SANITARY SEWER LAY OUT
LANKIN ADDITION
Wichita, Kansas
R.S. DELAMATER
CONSULTING ENGINEER
WICHITA, KANSAS

We are handing you herewith the tracings for the 48" storm sewer and the sanitary sewer which have been constructed to serve the Lankin Addition.

48" Storm Sewer Layout
Lankin Addition
May, 1969
R.S. Delamater
Consulting Engineer
Wichita, Kansas

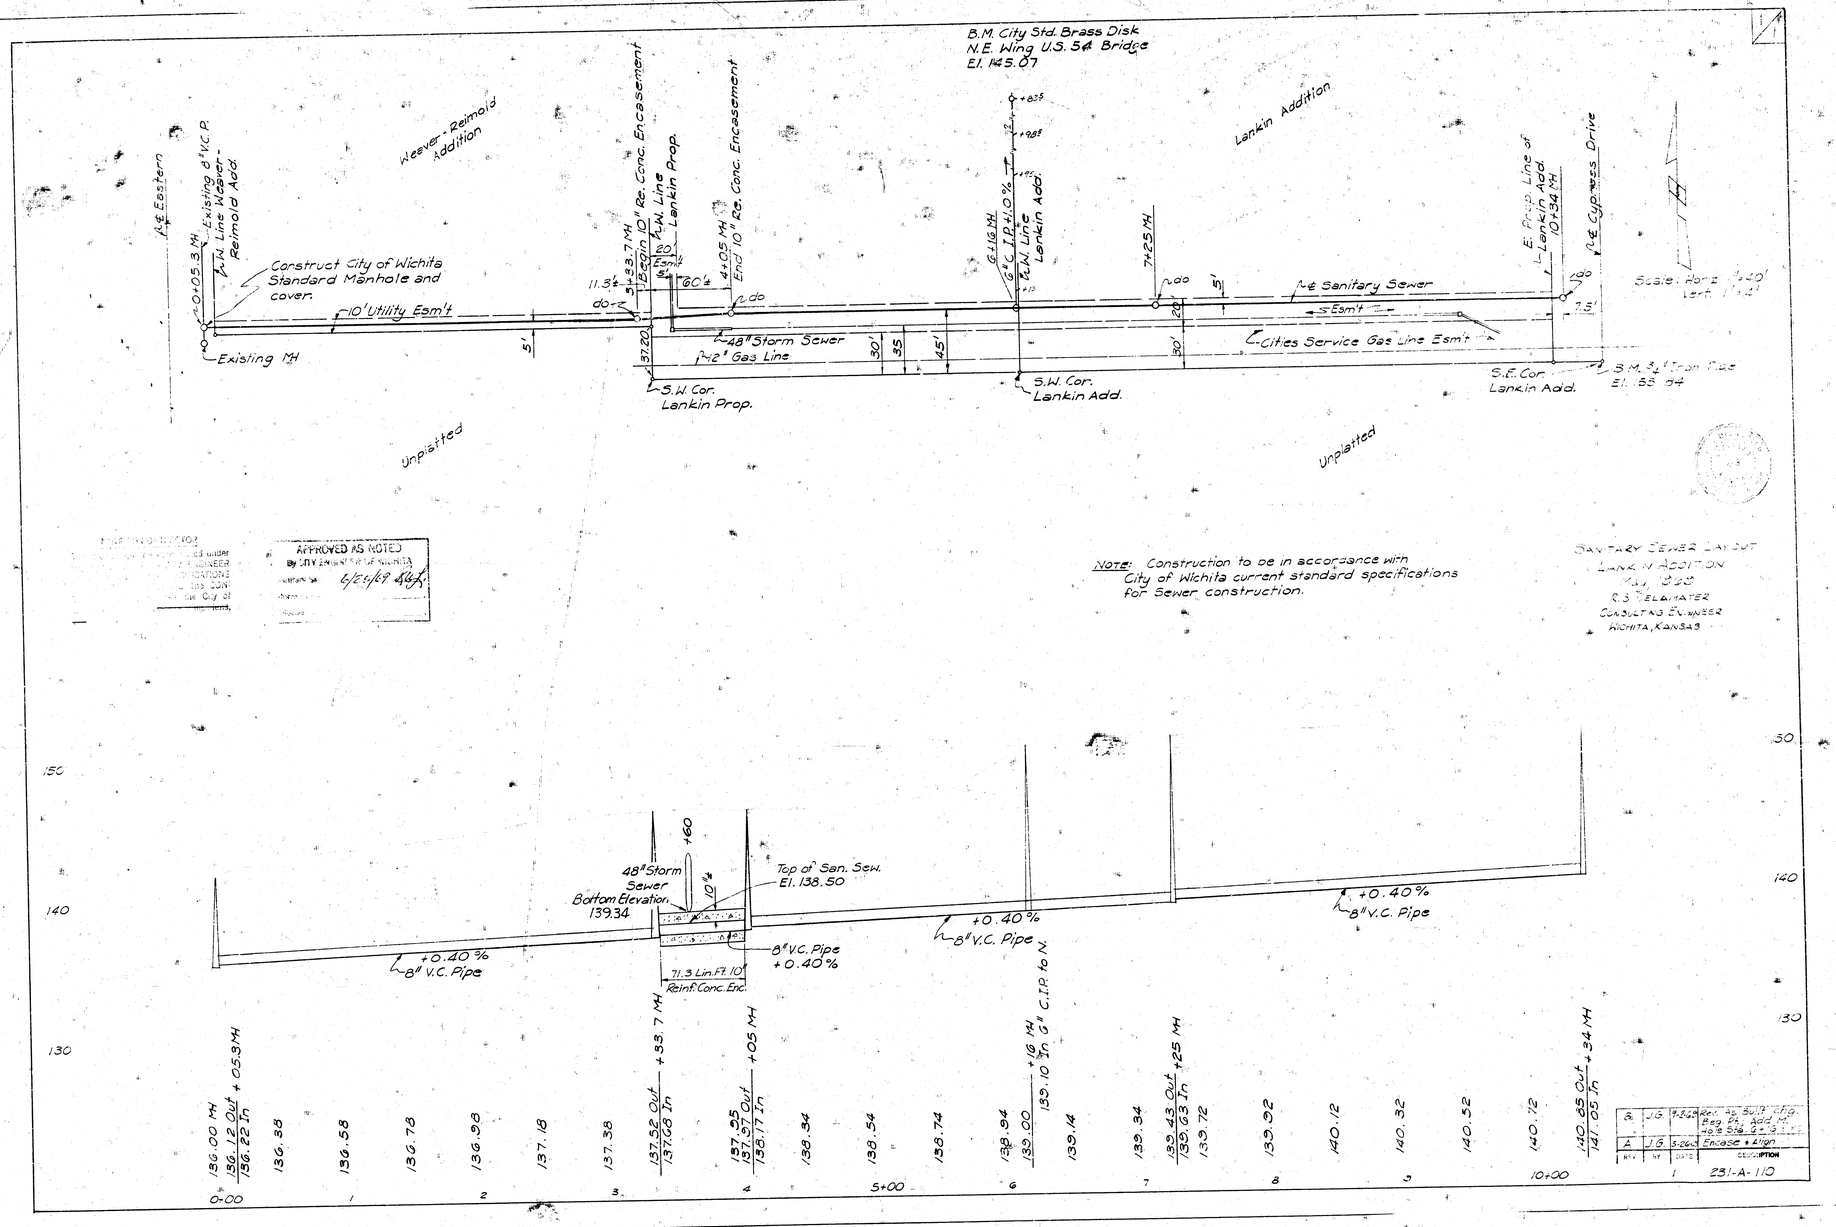
These tracings have been corrected to indicate the grades and dimensions as built and also to include the connecting lines into the sewers; in the case of the storm sewer we have indicated the location, flowline and grate elevation of the inlets which discharge into the manhole at the eastern end of the line.

NOTE, As built: All concrete manholes are built with standard concrete bottom sections, and brick extensions, with 2' square grate tops.

~~Bott. 12" Gas Line El. 149.77~~ 149.36 In (Lowered to below 48" Storm Sewer)

Note: As built revisions 12.5-69 are to show changes in the fields by others, and do not reflect changes in the plans by the consultant.
